Rezoning Transportation Analysis

Petition Number: 2020-070

General Location Identifier: Tax ID 06109202

Date	Description
05-19-20	First Review
06-24-2020	Second Review (KP)

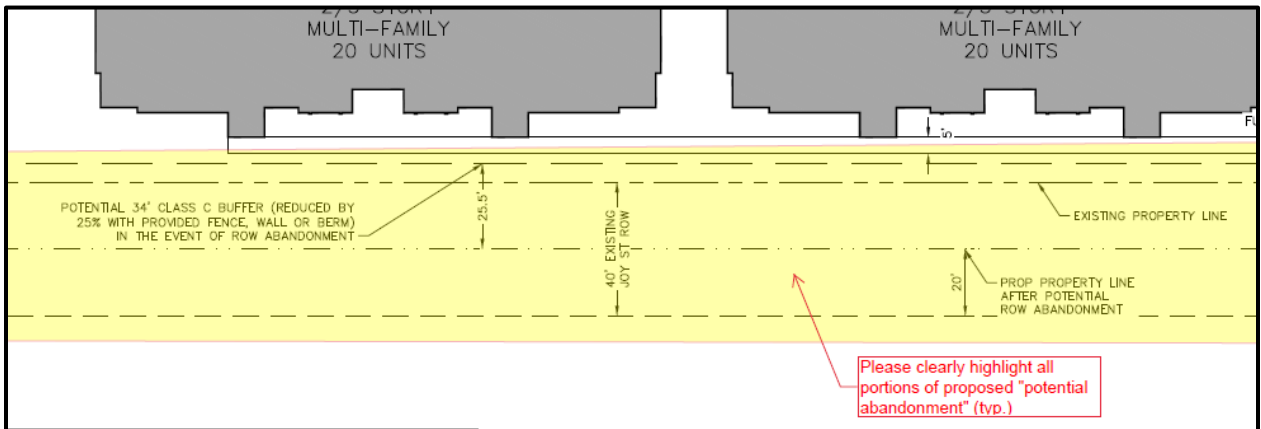
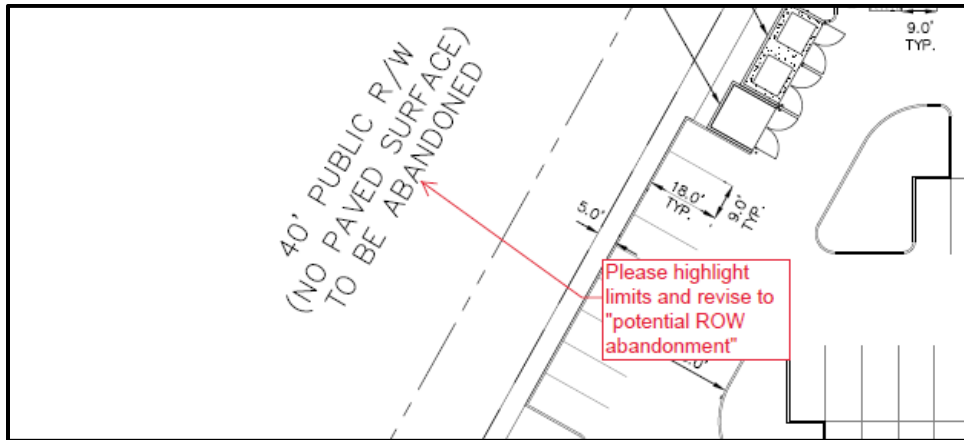
- ~~7. The petitioner should revise the site plan and conditional note(s) to remove the proposed marked crosswalks at the proposed public street intersections. Marked crosswalks are incorporated at~~

signalized intersections or at appropriate midblock pedestrian crossing facilities, in reference to the council-adopted Charlotte Walks Plan.
